STAFF RECOMMENDATION
1820 Fourth Avenue North
March 20, 2019

Application: New Construction – Infill and Outbuildings
District: Salemtn Neighborhood Conservation Zoning Overlay
Council District: 19
Map and Parcel Number: 08108030300
Applicant: Preston Quirk
Project Lead: Melissa Sajid, melissa.sajid@nashville.gov

<p>Description of Project: Application is to construct a new two-story duplex and two single-story detached garages.</p> <p>Recommendation Summary: Staff recommends approval of the infill project with the following conditions:</p> <ol style="list-style-type: none">1. The finished floor height be consistent with the finished floor heights of neighboring historic houses, to be verified by MHZC staff in the field;2. Staff approve the front setback in the field after staking;3. Staff approve the masonry samples prior to purchase and installation;4. The front walkways shall be extended to meet the public sidewalk;5. Staff approve the roof color, windows, doors, trim, porch floors, porch steps, porch railings, and parking pad materials for the infill prior to purchase and installation; and6. Staff approve the windows, pedestrian door, roof color, and trim materials for the outb

SITE PLAN

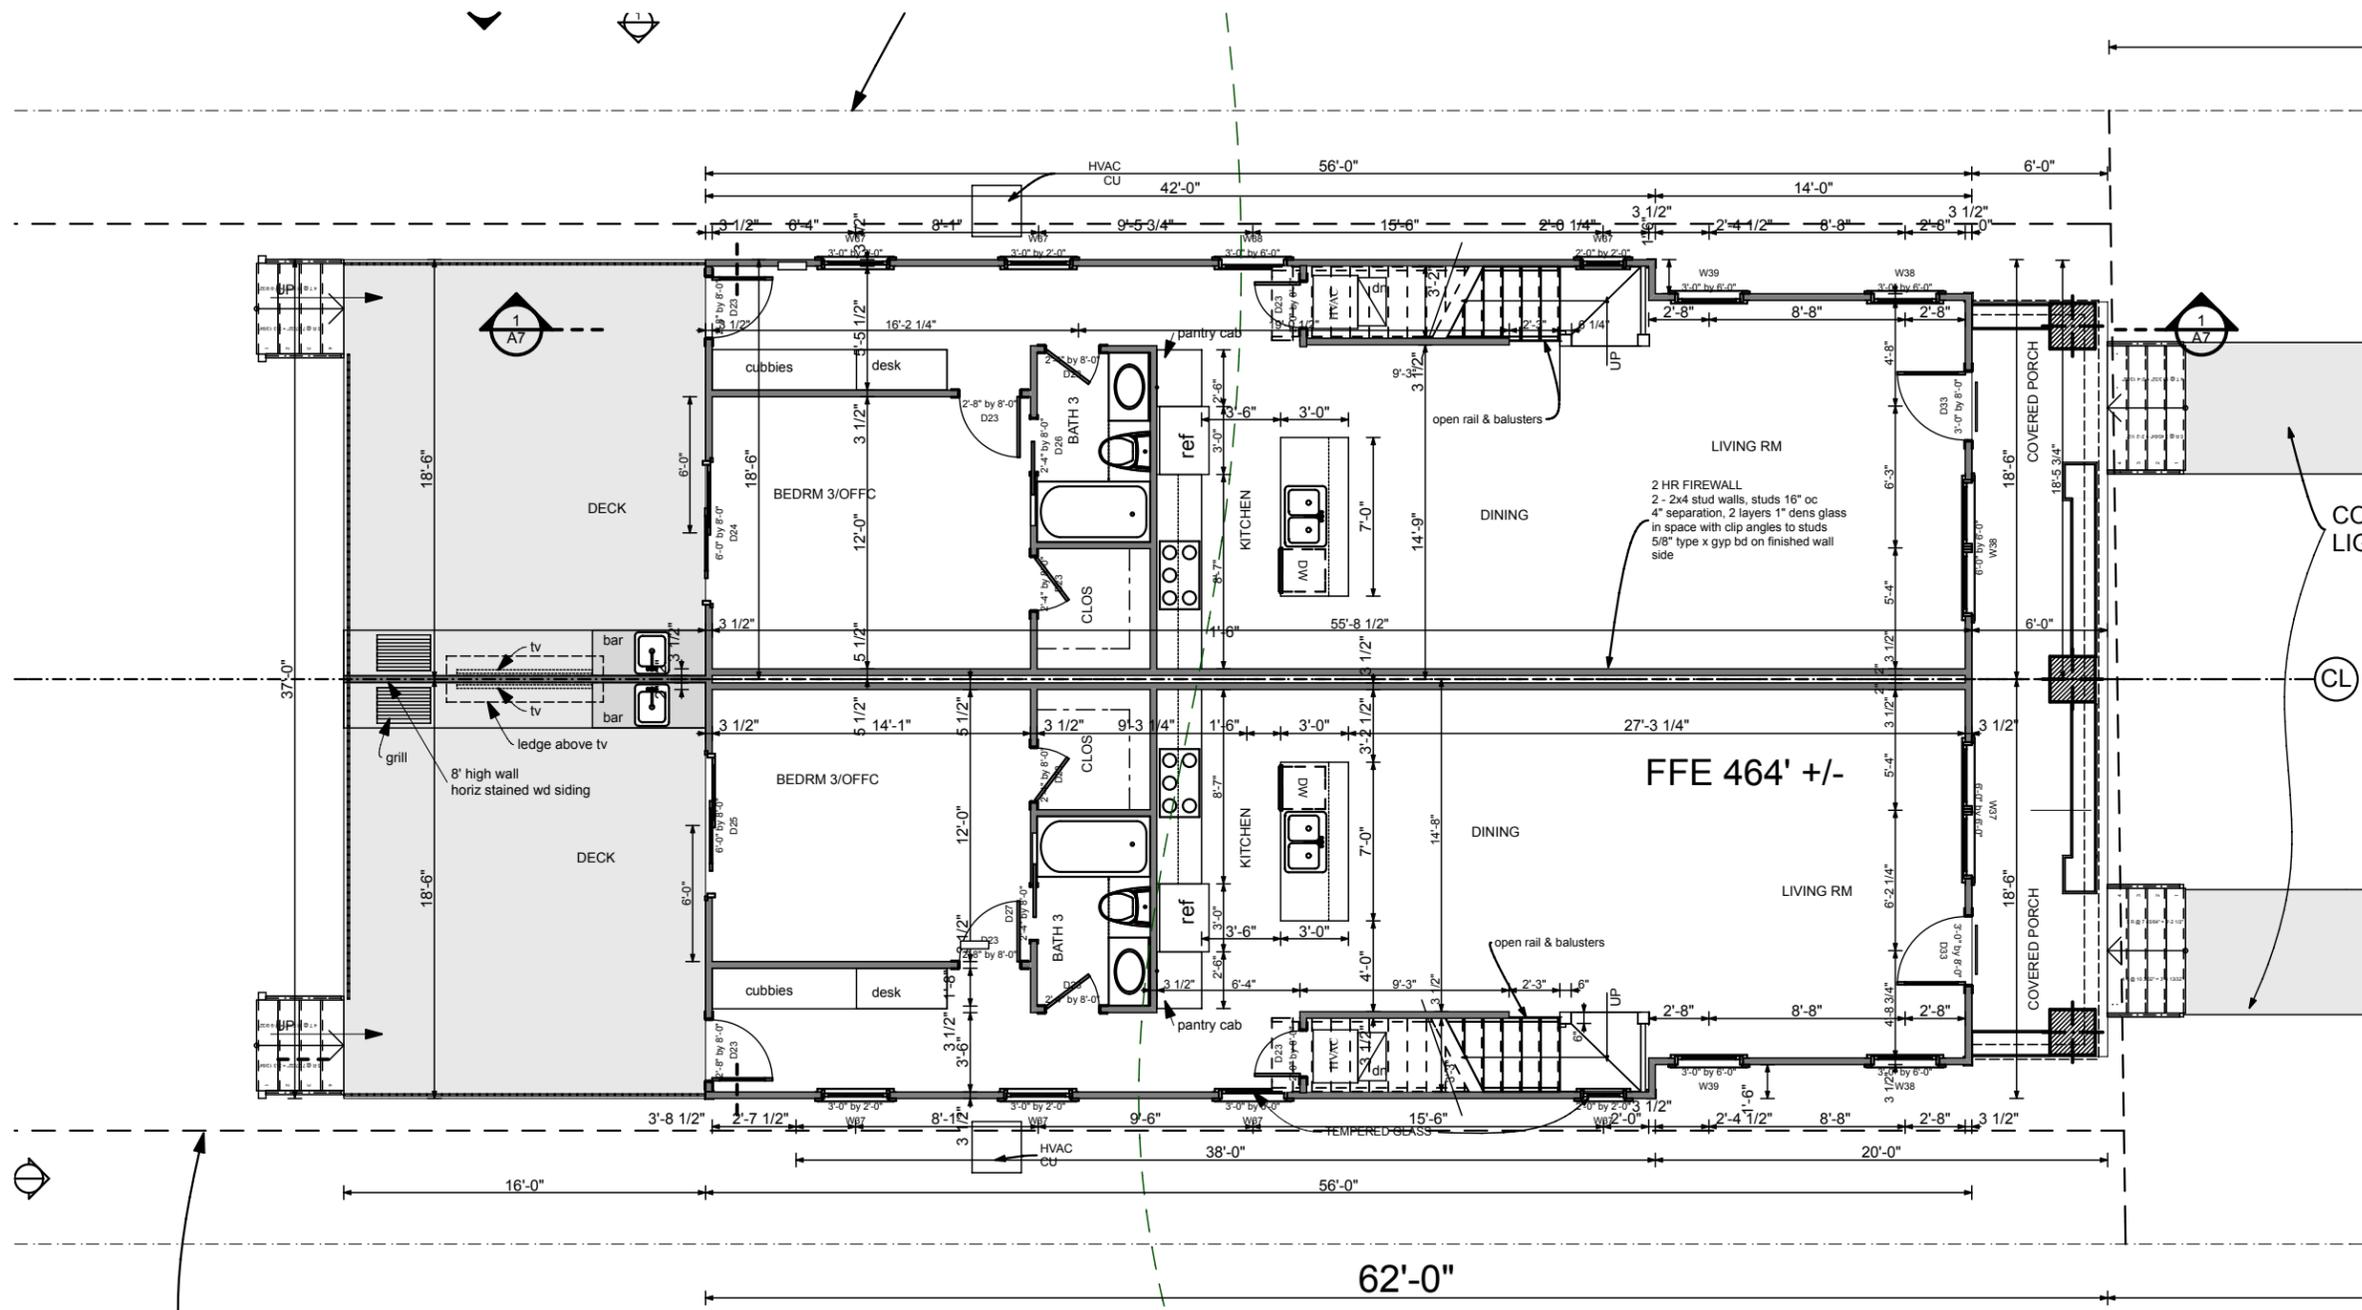
Setback & Rhythm of Spacing: The primary building is centered on the lot and will have a front setback of thirty-three feet, three inches (33'-3"), which is approximately the average of the front setbacks of the houses to either side. Both side setbacks are approximately six feet, six inches (6'-6"), and the rear wall of the house is sixty-seven feet (67') from the rear property line. The proposal meets all bulk zoning setback requirements.

Orientation: The proposed structure has a symmetrical façade. The house is oriented to face 4th Avenue North, as are all of the buildings on this block. Front walkways are proposed but stop short of connecting to the public sidewalk. Staff recommends that the walkways connect to the public sidewalk. Vehicular access to the infill will be from the alley.

1. The finished floor height be consistent with the finished floor heights of neighboring historic houses, to be verified by MHZC staff in the field;
2. Staff approve the front setback in the field after staking;
3. Staff approve the masonry samples prior to purchase and installation;
4. The front walkways shall be extended to meet the public sidewalk;

GARAGE (1)

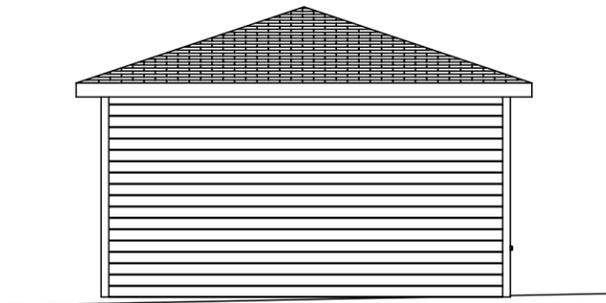
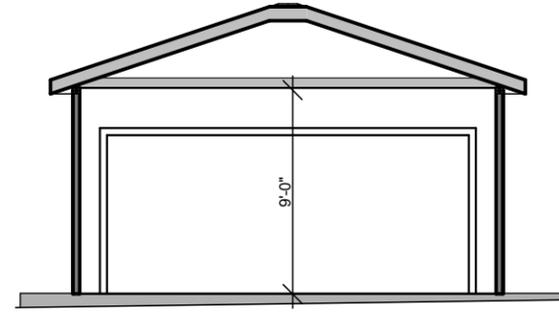
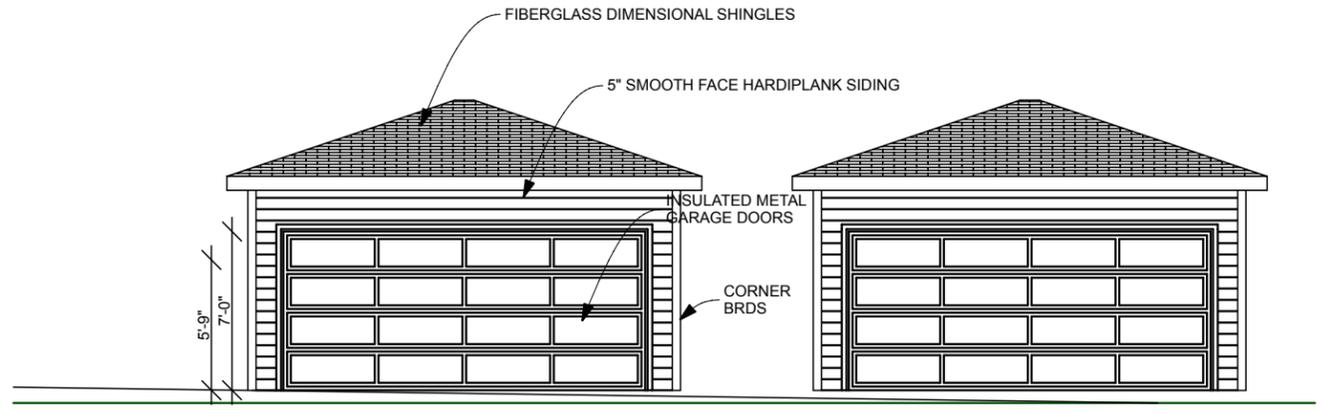
Outbuildings: The applicant is proposing two single-story outbuildings. The outbuildings cannot contain dwelling units since the house is proposed to include two units.

Design Standards: The outbuildings are single-story, which is appropriate behind a two-story house. The outbuildings has a utilitarian design that is appropriate for an accessory structure. Staff finds that the proposed design meets Section III.H.2 of the design guidelines.

Proposed	Color/Texture	Approved Previously or Typical of Neighborhood	Requires Additional Review?
Foundation	Concrete slab	Natural	Yes	
Cladding	Hardie Plank Lap Siding	5" reveal, smooth	Yes	
Roofing	Fiberglass dimensional shingles	Needs final approval	Yes	Yes
Trim	Not indicated	Needs final approval	TBD	Yes
Windows	Double hung	Needs final approval	Yes	Yes
Pedestrian Door	Half light	Needs final approval	Yes	Yes
Vehicular Doors	Insulated metal	Needs final approval	Yes

5. Staff approve the roof color, windows, doors, trim, porch floors, porch steps, porch railings, and parking pad materials for the infill prior to purchase and installation; and
6. Staff approve the windows, pedestrian door, roof color, and trim materials for the outbuildings prior to purchase and installation.
